POTENTIAL FINDING REPORT
SONGS 2&3 SEISMIC DESIGN VERIFICATION

REVISION --

DESIGN CALCULATION NO. DC 339 - E16
REVISED 6-5-77

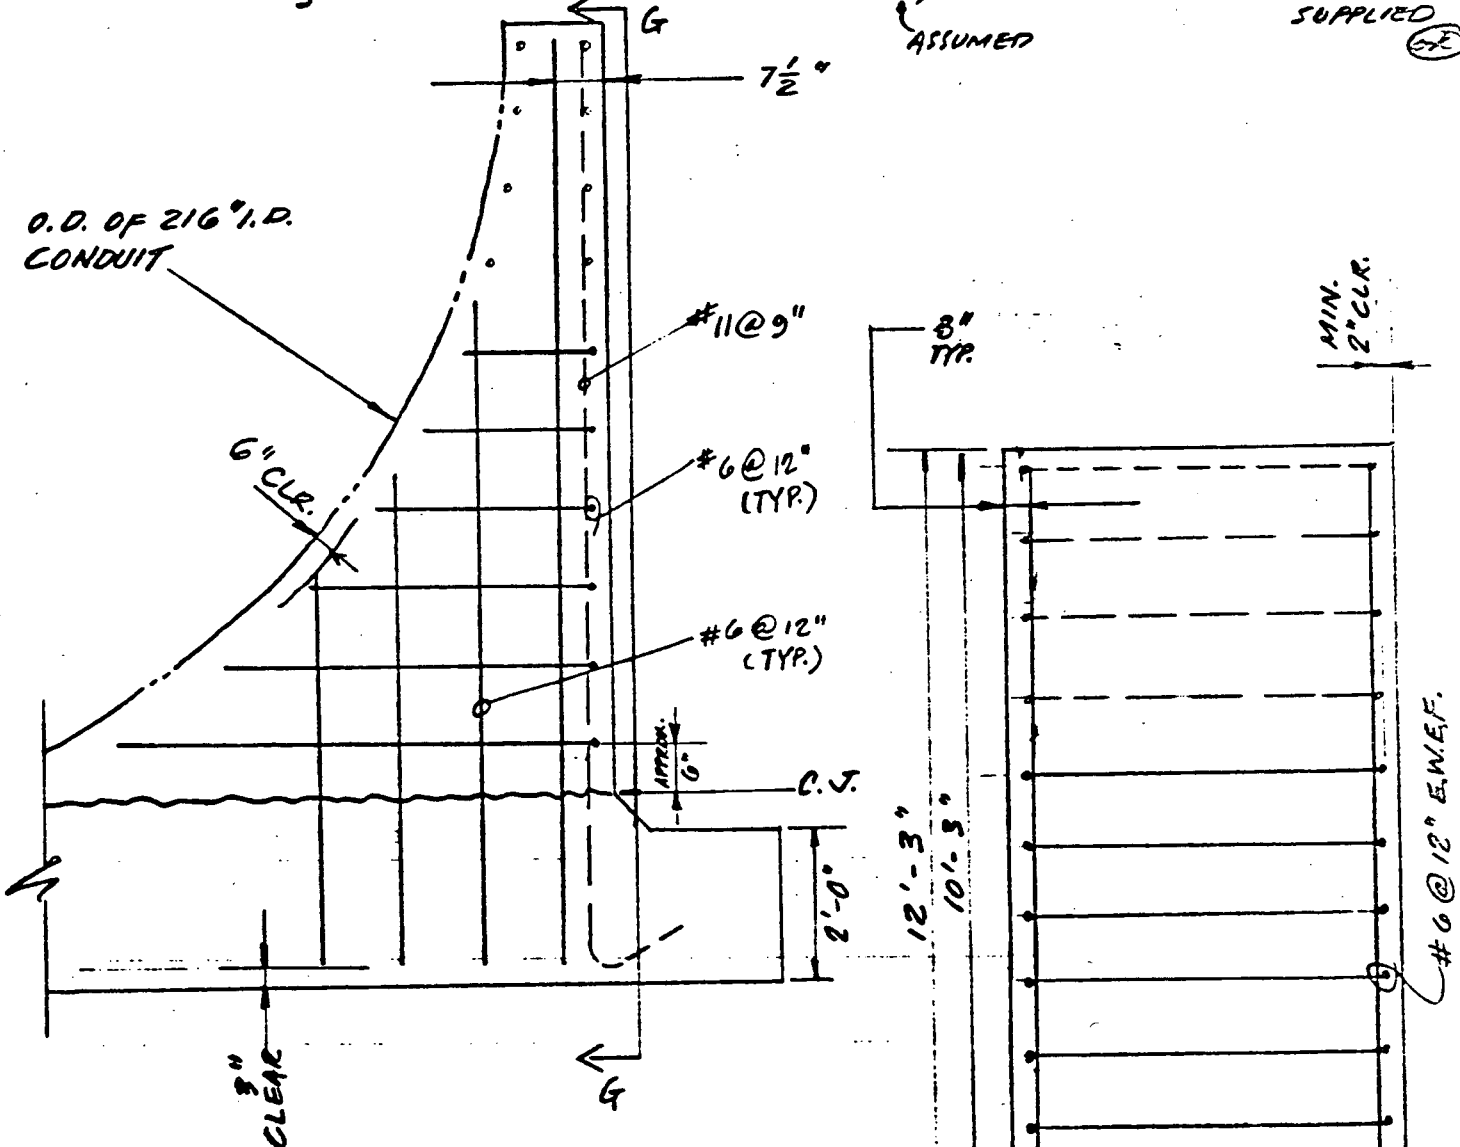
Verify that the calculation pages associated with the construction joint modification were reviewed consistent with the intent of existing QA procedures, as stated in SCE's initial response to this PFR.

A subsequent check of the calculations demonstrated that only sheet El6 was actually revised following initial approval of original calculations on 5/30/78. We are enclosing this sheet which is dated 6/5/78 and initialed by the preparer, Mr. S. R. Wright, Registered Civil Engineer No. 26,452. This sheet also was initialed by the Independent Review Engineer on 6/6/78, Mr. A. J. Fohrer, Registered Civil Engineer No. 26,195.

NUMBER **5131363**

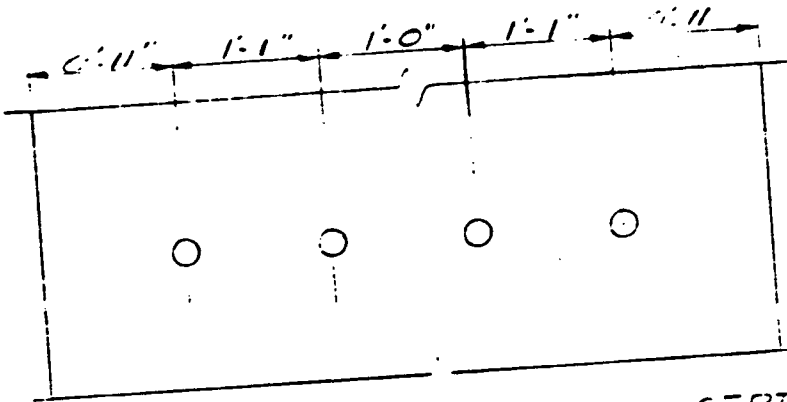
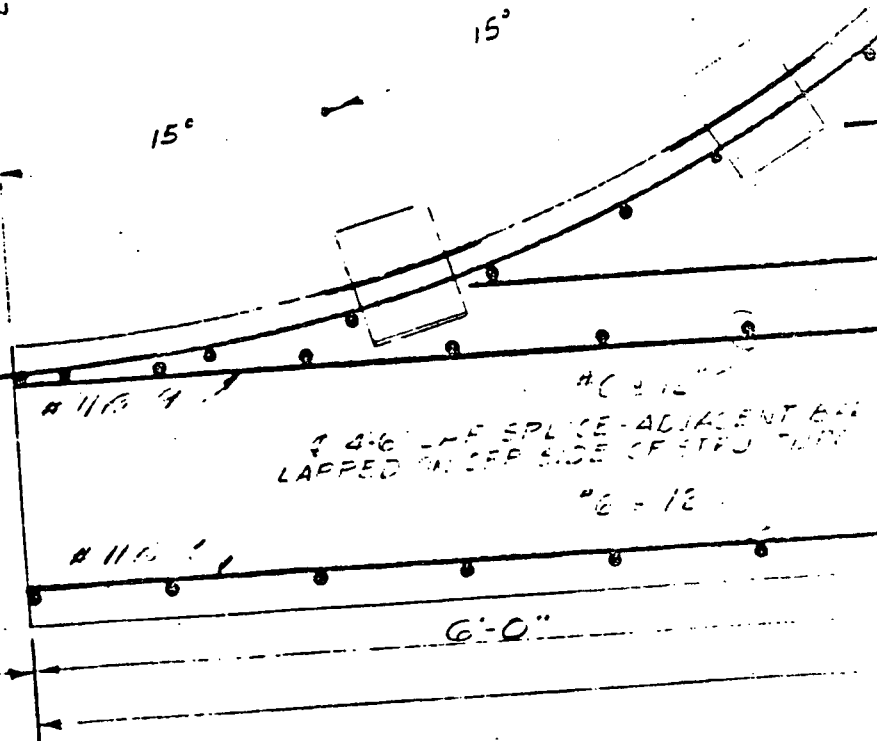
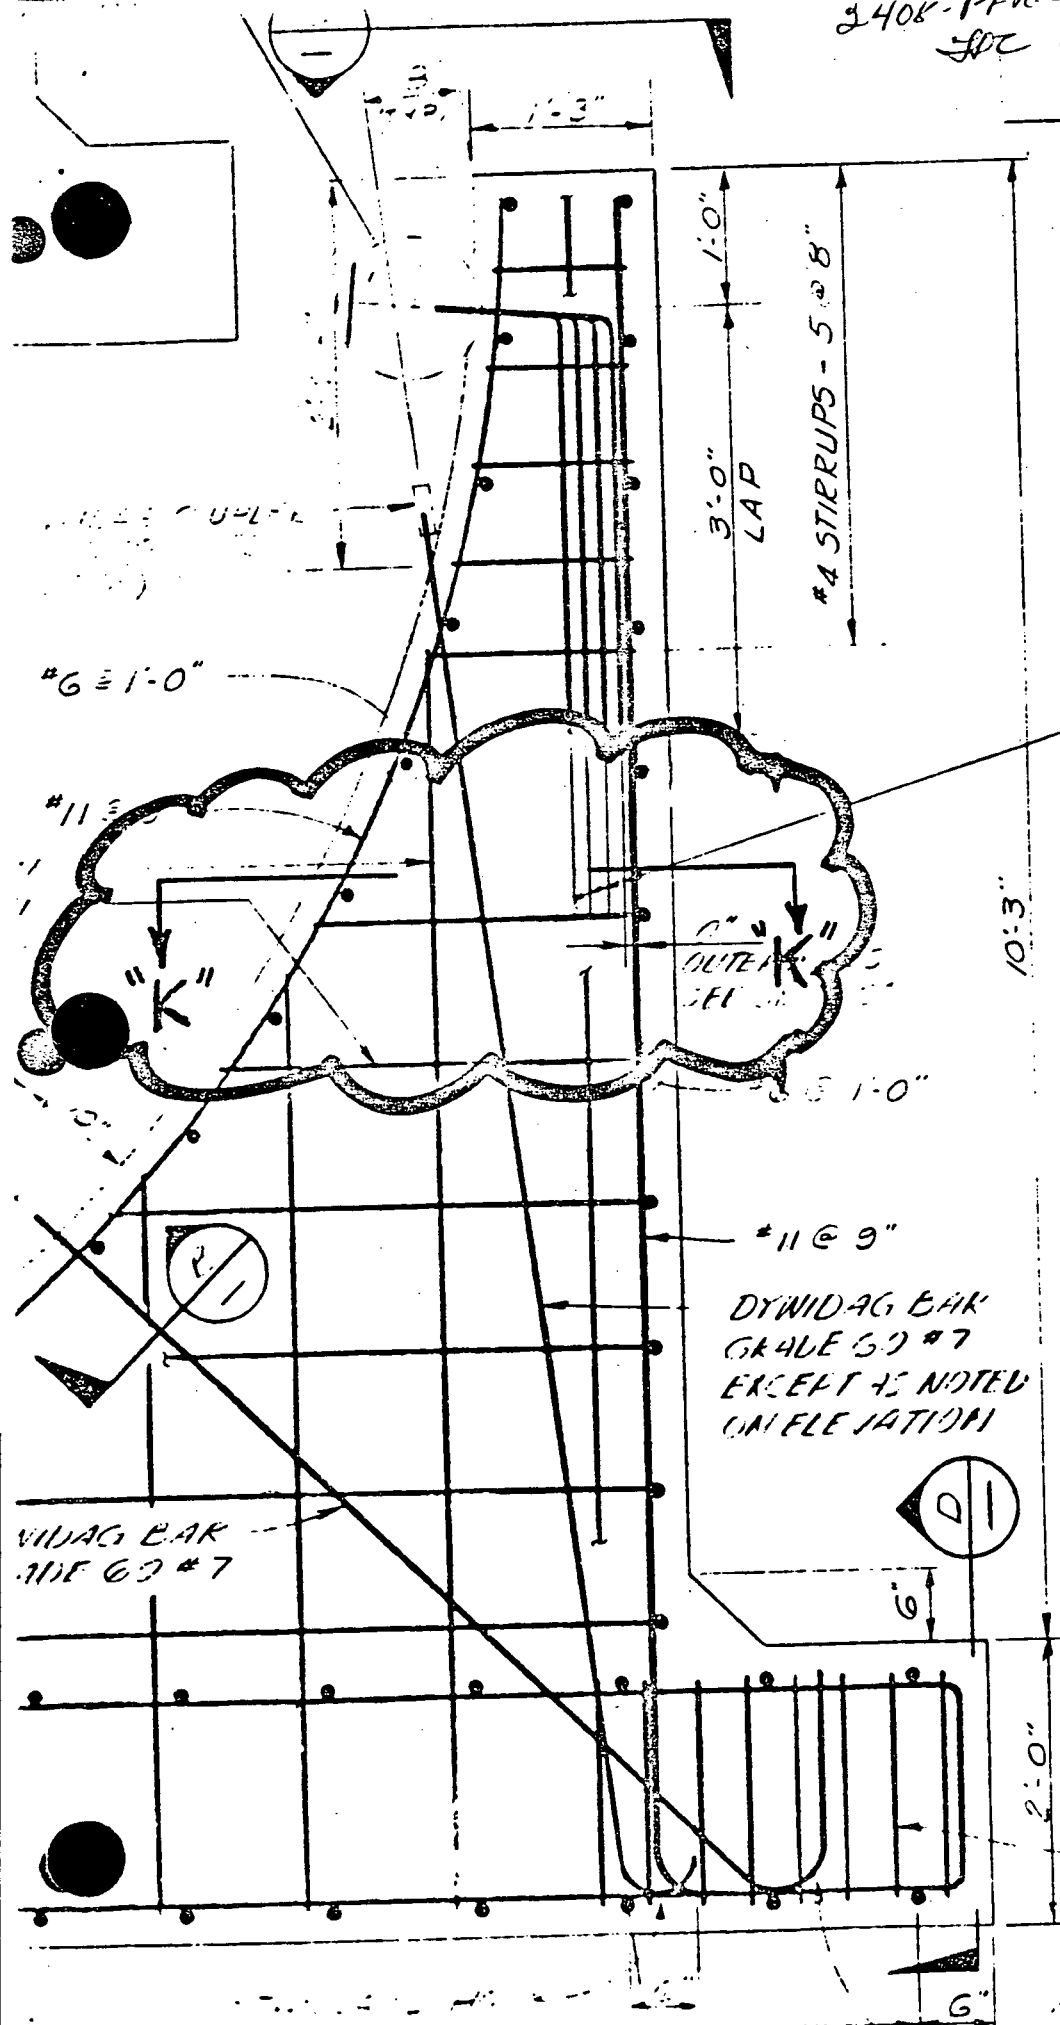
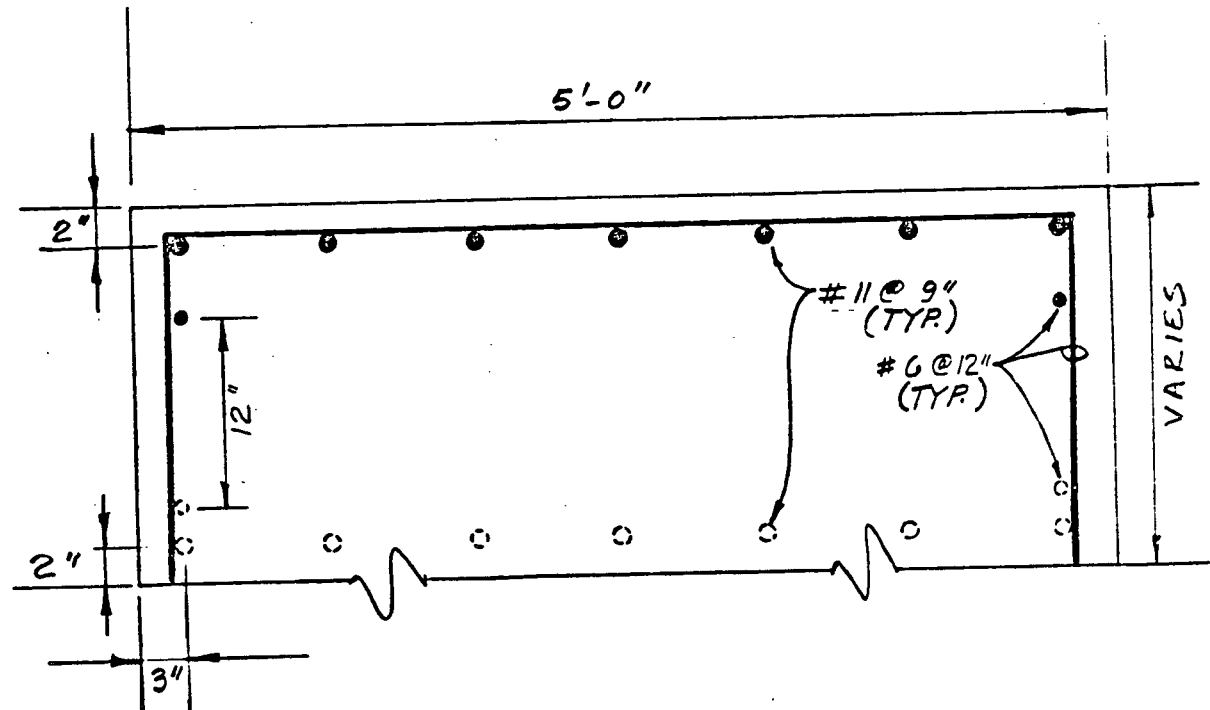
2- REVISE BUTTRESS REINFORCEMENT, AND ADD #6 BARS @ 12"
SEE SHEETS NO. 2 & 3.

2- REVISED STEEL ON BUTTRESS FACES TO ALLOW CONTRACTOR-
REQUESTED OPTION OF CONSTRUCTION JOINT. DETAIL IS
REQ'D. TO CLARIFY DESIGN INTENT.

2- REVISION ENABLES PLACEMENT OF CONSTRUCTION JOINT TO
FACILITATE CONCRETE PLACEMENT. MEETS DESIGN INTENT.EVALUATION - ☒ APPROVE ☐ REJECT

Cable Tray Hanger Drawing #37185, Rev. 2

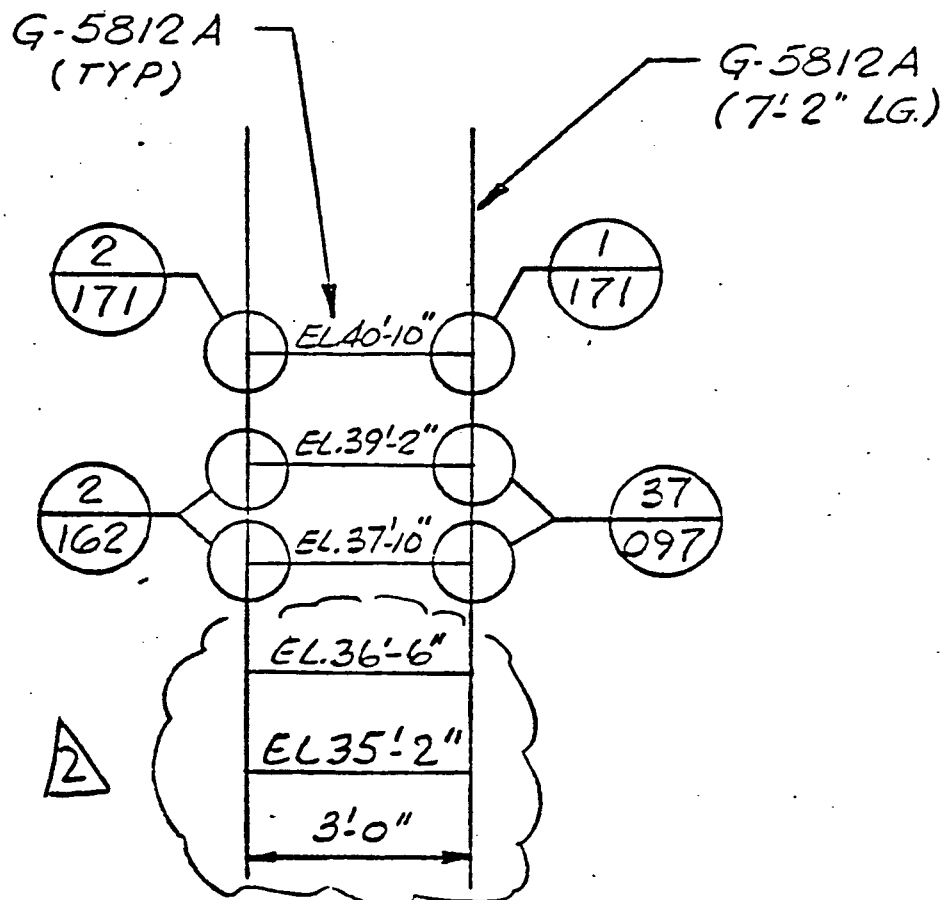
Drawing #37185, Rev. 2, (Attached) is an unauthorized revision signed by the draftman only, with no issue date, thereby indicating a drawing control violation. The drawing control log shows the last revision of this drawing to be Rev. 1.

How come we
HAVE THIS? IT HAS
NOT BEEN RELEASED
MD
G

The Drawing Control Log and the Drawing Control Card File (microfilms) were reviewed at San Onofre on 2/24/82 for evidence that Drawing #37185, Rev. 2 had been received at the jobsite - none was found. Impact - zero.

FIG. 2. VALVE INSTL. MODEL COMPARISON. SCALE: $\frac{1}{2}$ " = 1 FT.

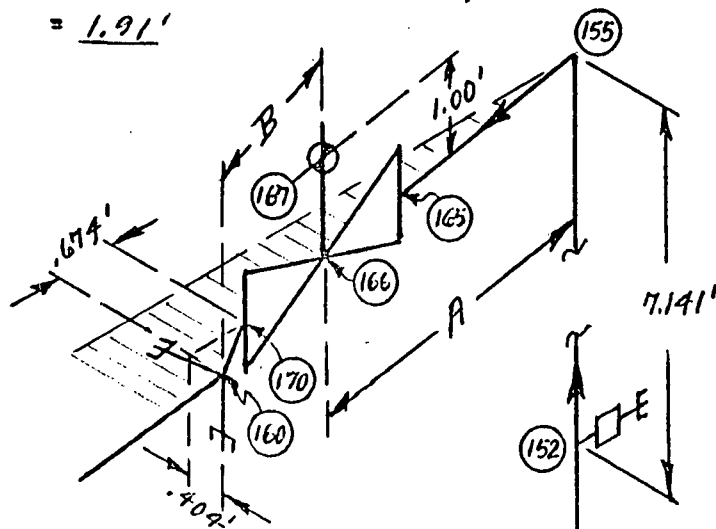
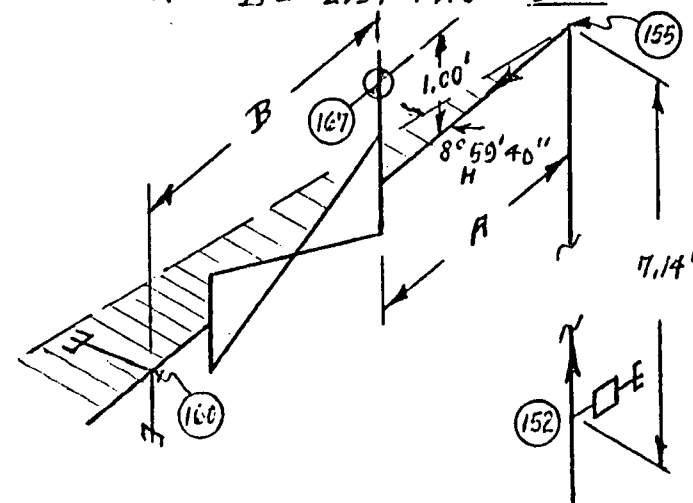
DESCRIPTION OF POTENTIAL FINDING: Valves 2HV9331 (node 167), 2HV9322 (node 367), and 2HV9325 (node 427) are identical pieces of hardware per valve drawing 74R-008H (Target Rock Corporation). The drawing shows a weight of 992 lbs and C.G. location as indicated on Attachment Sketch Fig. 1. The Input Data Scan for nodes 367 and 427 shows an added weight of 1000 lbs and a C.G. location 1 ft above the up-flow circumferential weld. The lateral offset of 1 3/8", which may be left or right, since the motor operator may be rotated 180° required, has been ignored. The node 367 and 427 modeling represent a reasonable simulation. However, the C.G. at node 167 is located 1 ft above the midpoint between the up-flow and down-flow circumferential welds. This puts the valve C.G. approximately 1.19 ft too close to support point 160 and may be unconservative for seismic loading. See Att. Fig 2.

*There also appears to be a discrepancy in the pipe simulation from node 170 to 160 as indicated by dimensions .674' and .404' on Fig. 2.

A seismic computer analysis has been performed with the valve at node 167 accurately modeled to represent that as shown on Fig. 2 of attachment to PFR-F040. Results of this analysis show that the resultant acceleration at the valve C. G. has increased from 0.25G to .54G which is still below the allowable limit of 8.66G.
